MEMORANDUM

From: Jordan Nader & John Seryak, PE (RunnerStone, LLC)

RE: Review of The Brattle Group Report, "Impacts of Announced Nuclear Retirements in Ohio and Pennsylvania"

Figure 1: Ohio Electricity Generation, CO₂ Emissions since 2005

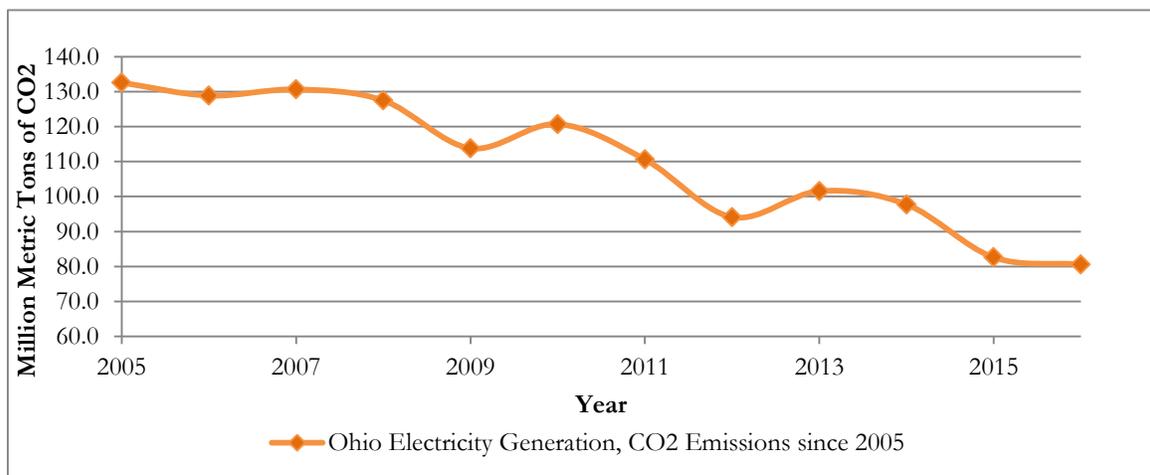
The first point, while true, ignores the fact that Ohio’s electric generation emissions have been falling steadily since 2005, at an annual rate of 4.95 million metric tons of CO₂ for an absolute reduction of 51.98 million metric tons of CO₂⁸, a 39.2% drop. The report asserts that the emissions avoided from these nuclear plants are worth \$921 million per year, based on an approximate output of 39 million MWh. This would equate to approximately \$44/metric ton CO₂ which is a significantly higher valuation than that of a recent auction carried out by the Regional Greenhouse Gas Initiative (RGGI) of \$5.35/ metric ton of CO₂.
